ADDENDUM NO. 1

175th Wayfinding Channelization Improvements Project Bid No. 23-C2902

5/5/2023
8 Pages

NE 175TH ST TYPICAL SECTIONS
STA 10+00.41 TO STA 16+18.21

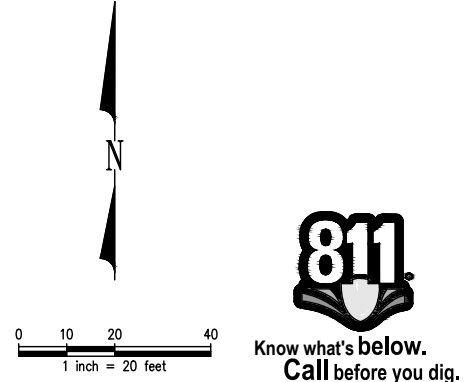
①	5/5/23	ADDENDUM 01 - THICKEND EDGE	CJO	NDA
No	Date	Revision	By	Appr

PV02

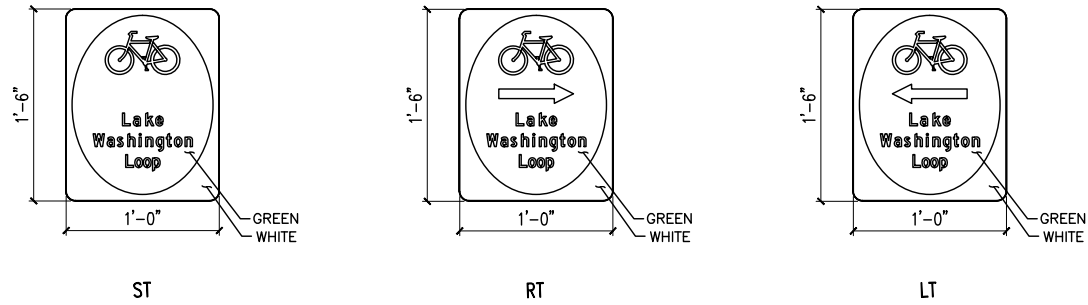
1	5/5/23	ADDENDUM 01 - THICKEND EDGE	CJO	NDA
No	Date	Revision	By	Appr

RRFB BIKE CROSSING SIGN

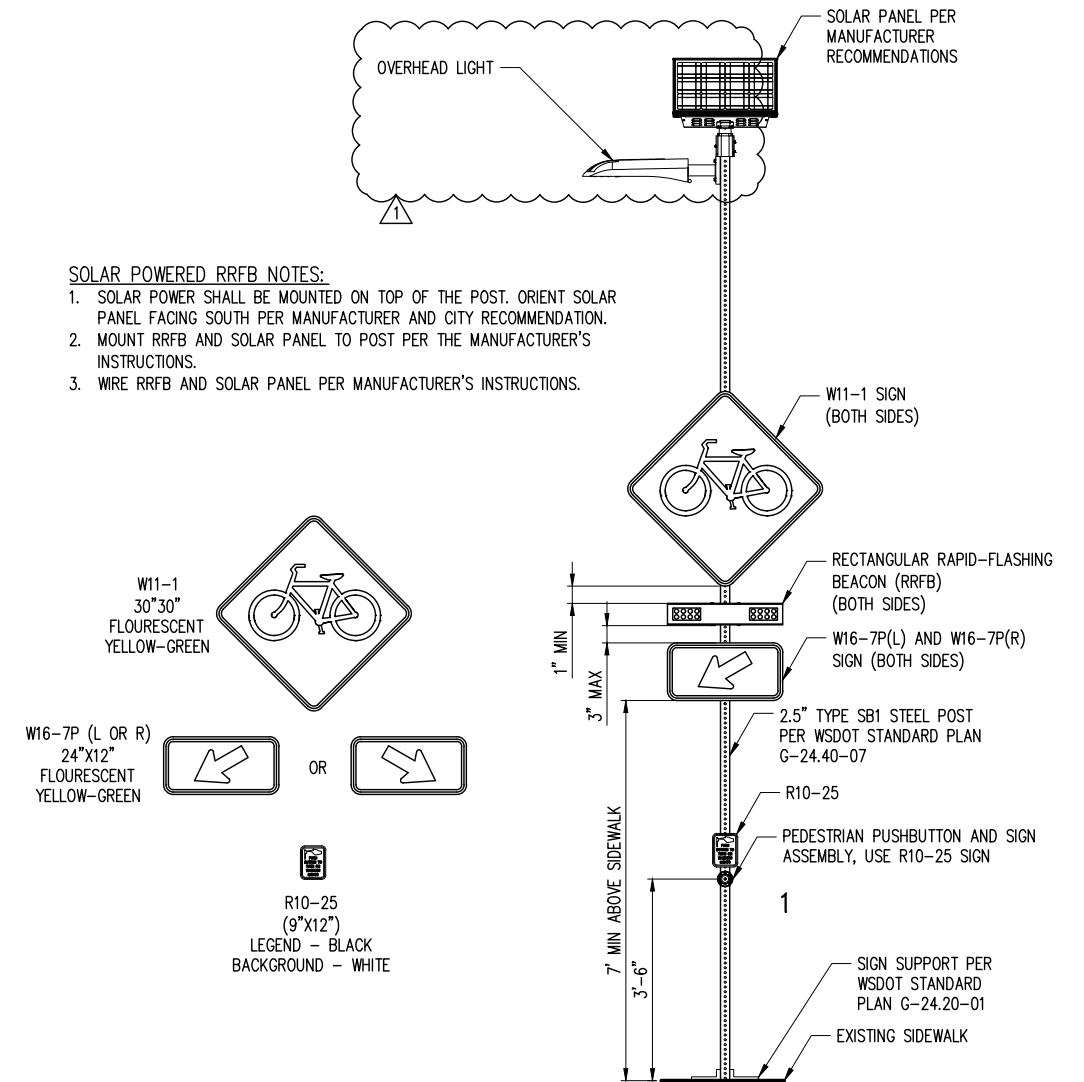
5/5/23	ADDENDUM 01 - THICKEND EDGE	CJO	NDA
No	Date	Revision	By

- SOLAR POWER SHALL BE MOUNTED ON TOP OF THE POST. ORIENT SOLAR PANEL FACING SOUTH PER MANUFACTURER AND CITY RECOMMENDATION.
- MOUNT RRFB AND SOLAR PANEL TO POST PER THE MANUFACTURER'S INSTRUCTIONS.
- WIRE RRFB AND SOLAR PANEL PER MANUFACTURER'S INSTRUCTIONS.
